CITY OF DUNDEE
PLANNING COMMISSION AGENDA
City Council Meeting Chambers
620 SW 5th Street
Dundee, OR 97115
P.O. Box 220

- S 16-20, Alder Terrace Subdivision

The request is to divide two existing parcels into 12 lots for a subdivision known as Alder Hill subdivision. The proposal is a relatively straightforward subdivision that meets all of the lot dimensional and access requirements in the Dundee Development Code. The proposed subdivision will improve their respective street frontages on Alder Street and 7th Street with sidewalks. The biggest issue facing the proposed subdivision will be to provide an alternate method for stormwater than what is proposed, due to the lack of existing facilities on the adjacent property that were not installed at the time of development. There are several options for the alternate stormwater plan, and those will be reviewed and approved by the City Engineer per the conditions of approval. The applicant did provide an erosion control plan that will be followed during construction to mitigate impacts to neighboring properties.

101
 SANITARY SEWER & WATER PLAN
 SCALE: 1" = 60'

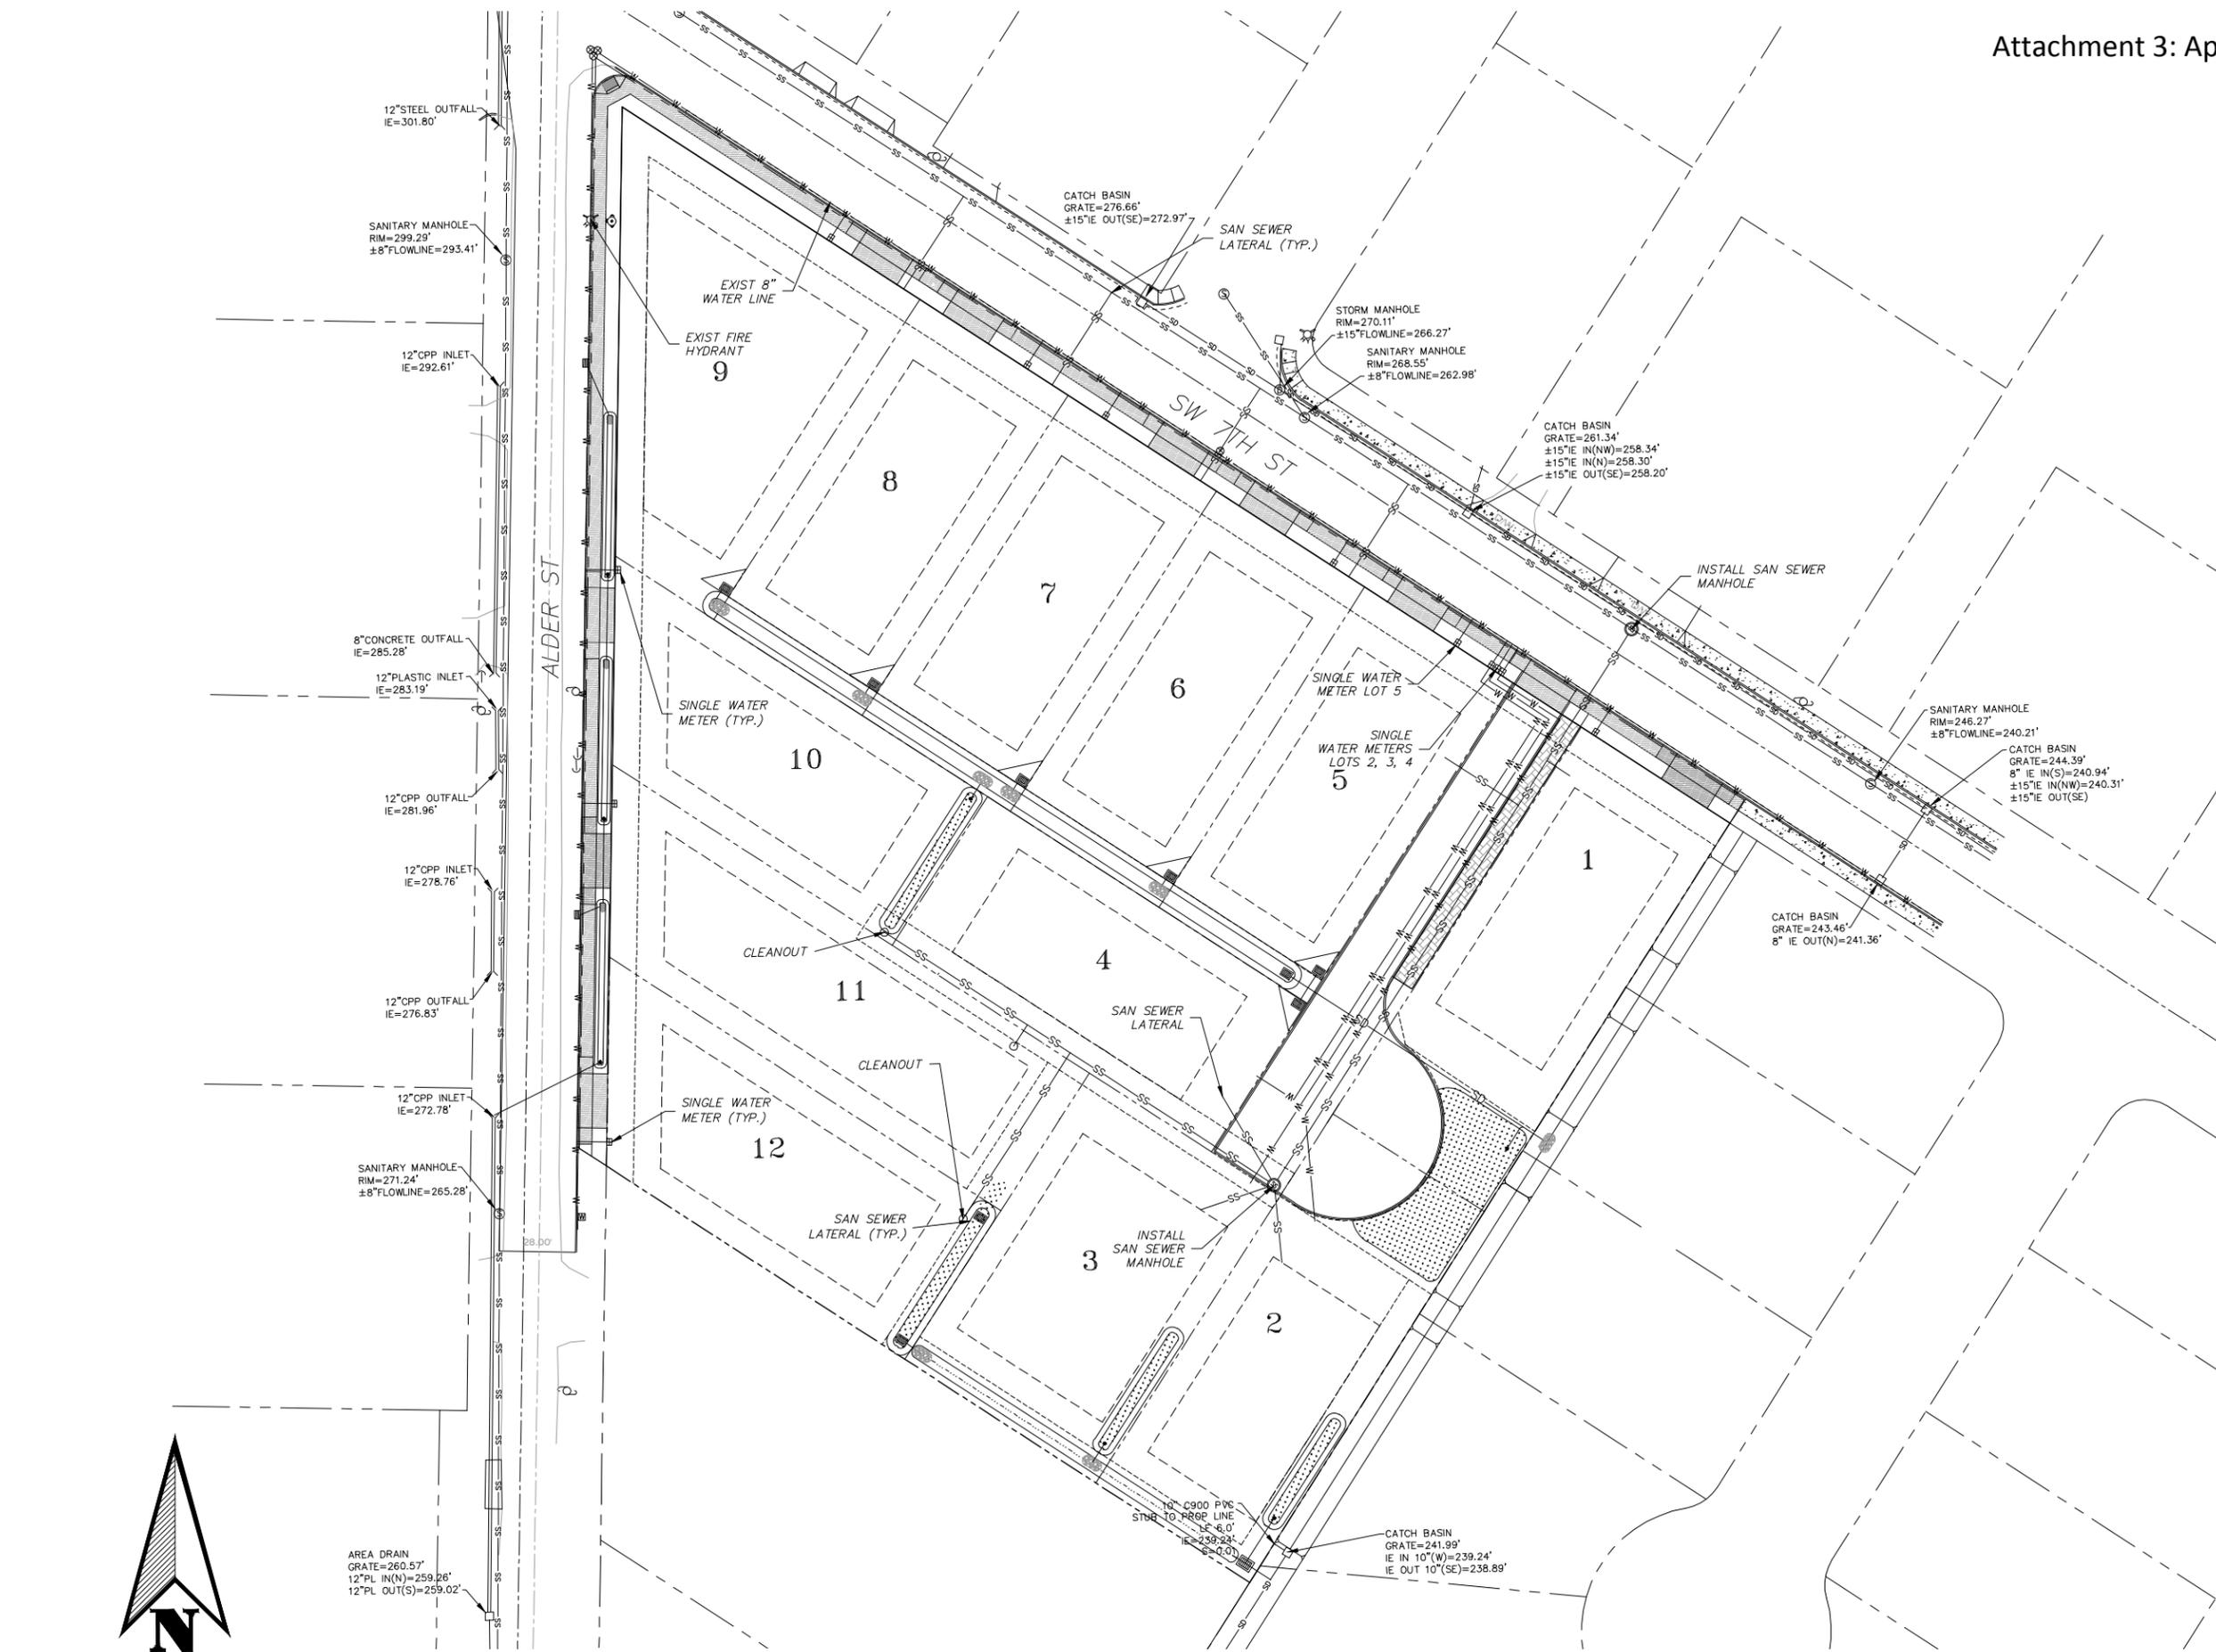
- **Water:** Provide individual laterals within easements to serve each lot.
 - **Sewer:** The proposed sewer layout does not meet city standards as private laterals are not to be combined (one lateral for each service that extends to the main) and laterals are not permitted to connect to manholes. Provide a revised utility plan showing sewer extension to all lots that meets city standards and requirements. Individual sewer laterals will need to be provided to serve each lot through easements.
